Application for amendment to a works approval

Works approval number	W6088/2017/1
Works approval holder	Thunderbird Operations Pty Ltd
ACN	611 351 743
File number	DER2017/001386
Premises	Thunderbird Mineral Sands Project Great Northern Hwy WATERBANK WA 6725 Legal description – Mining Lease M04/459 & L04/85
Date of report	10 March 2020
Decision	Amendment granted

Amendment description

▲ Revised ore processing process flow sheet

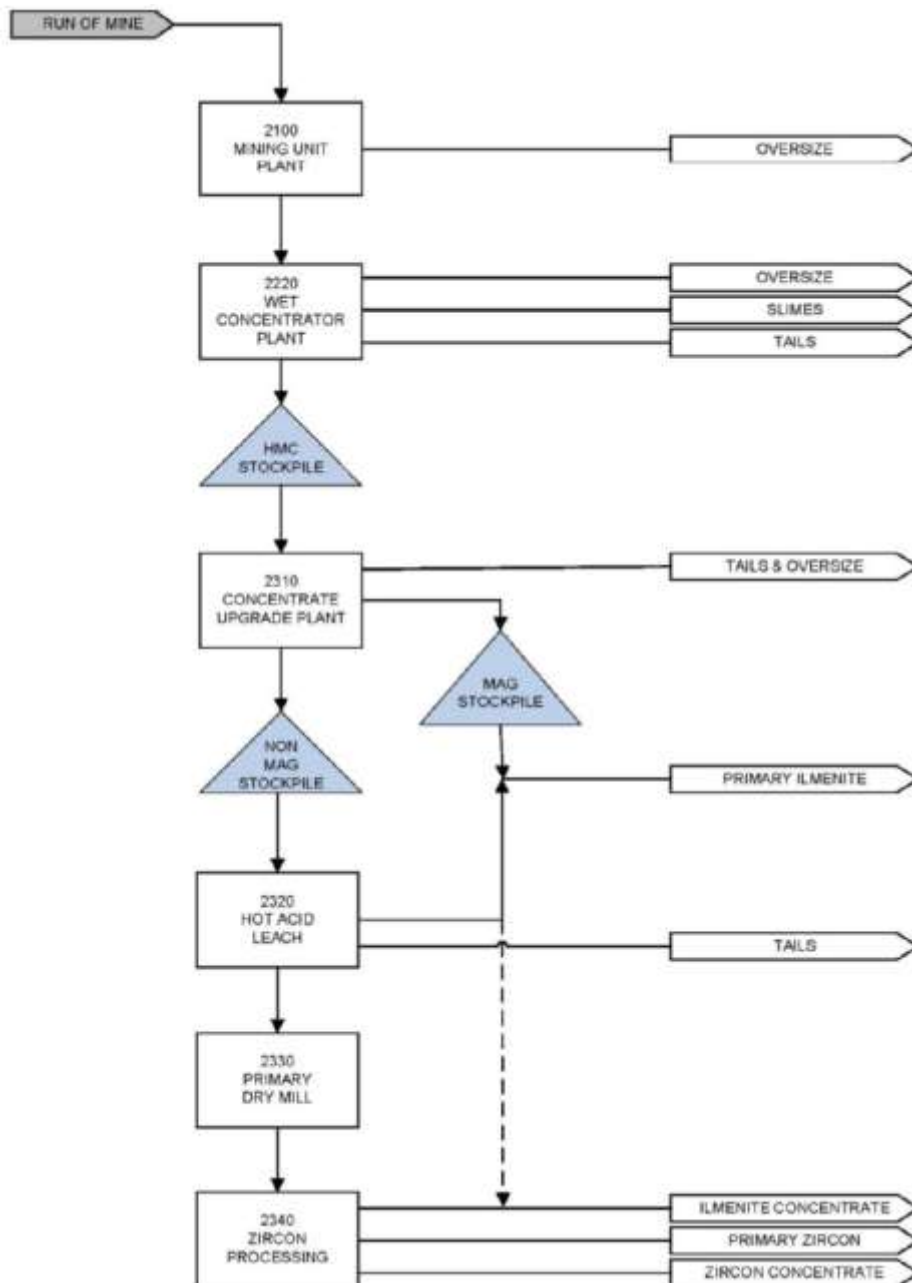
Secondary processing through the concentrate upgrade plant (CUP) and mineral separation plant (MSP) will change. The heavy mineral concentrate (HMC) will be further processed by a combination of gravity, magnetic and electrostatic separation methods in both wet and dry processes to separate the valuable minerals. However only four product streams will be produced instead of five: premium zircon, zircon concentrate, primary ilmenite and ilmenite concentrate. This will involve:

- removing the ilmenite processing circuit, such that only a primary ilmenite product will be produced. Low temperature roast ilmenite and titano-magnetite products will no longer be produced. Some primary ilmenite will also be blended with non-magnetic zircon tailings to produce an 'ilmenite concentrate' product;
- removing the HiTi 88 leucoxene circuit – HiTi 88 product will no longer be produced; and
- fitting the hot acid leach (HAL) with electrostatic separation equipment to provide an improved HAL magnetic-conductor stream to be blended with the CUP magnetic material which together will form a 'primary ilmenite' product.

These changes are illustrated in the below revised ore processing process flow sheet.

The function of the proposed WCP and CUP remain unchanged, with the WCP producing a HMC for further processing in the CUP, and the CUP separating the magnetic minerals (mainly ilmenite) from the non-magnetic minerals (mainly zircon), and then further upgrading the non-magnetic fraction.

Management and disposal of waste streams of clay slimes, sand tailings and oversize material also remain unchanged. Revised process flow diagrams (PFDs) have been submitted that supersede the existing diagrams.

The proposed HAL is similar to that approved in the existing works approval, however with the addition of electrostatic separation equipment to provide an improved HAL magnetic-conductor stream. The non-magnetic concentrate stream will be passed to the primary dry mill for further processing. Revised PFDs have been submitted that supersede the existing diagrams.

The primary dry mill will process the non-magnetic concentrate from the CUP, to separate minerals with conductive properties (ilmenite, leucoxene and rutile) from non-conductive minerals (silica, zircon, monazite, alumino-silicates). The proposed primary dry mill has been modified by the removal of the HiTi 88 recovery circuit. It now produces a zircon concentrate which passes to the next stage of zircon processing.
